INFORMATION FORM - SEPTIC SYSTEM REPAIR/UPGRADE

RECEIPT DATE: 02/26/2020 **ONSITE SEWAGE DISPOSAL SYSTEM** P 568769

PROPERTY ADDRESS: 820 Driver Road

SITE INSPECTION SHEET

LOCATION DIAGRAM

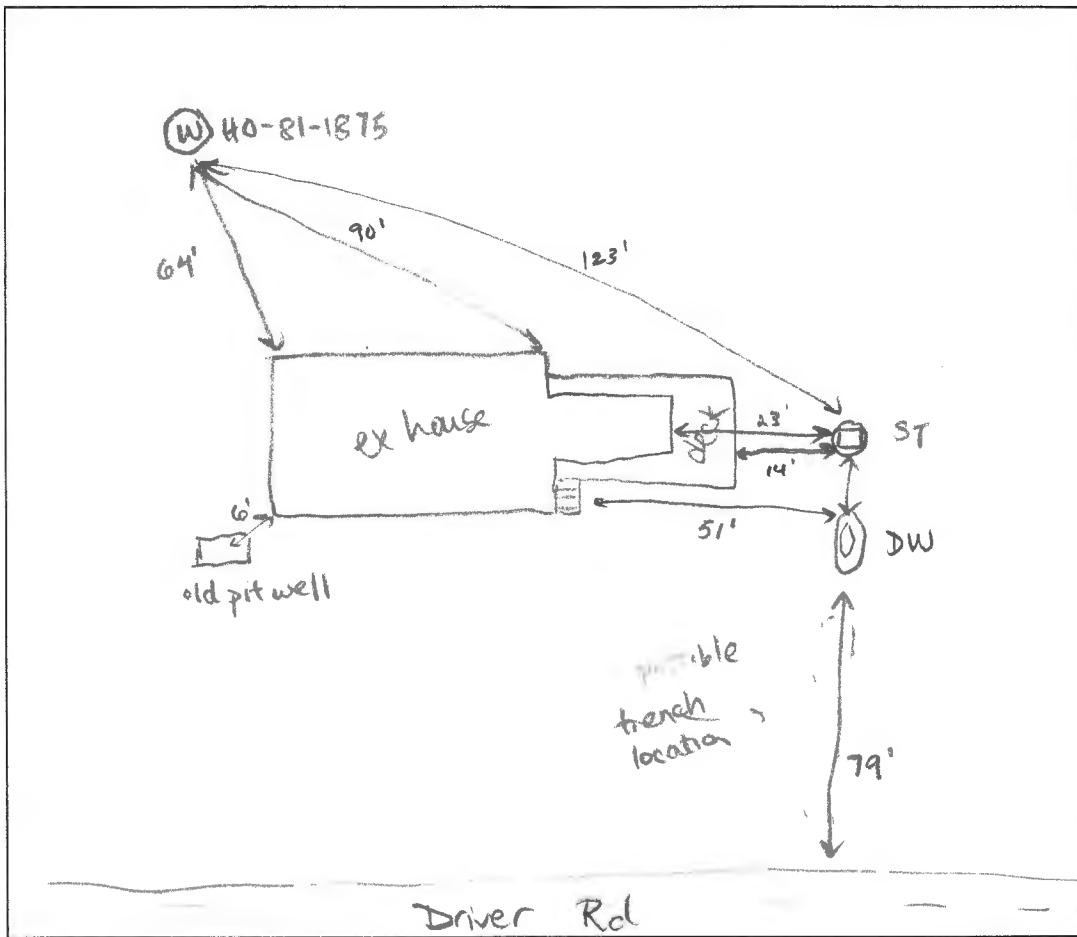
COMMENTS: Contractor intends to place new 1250 gal (3 bedrooms) tank in same place. Old pit well must be abandoned prior to septic work.
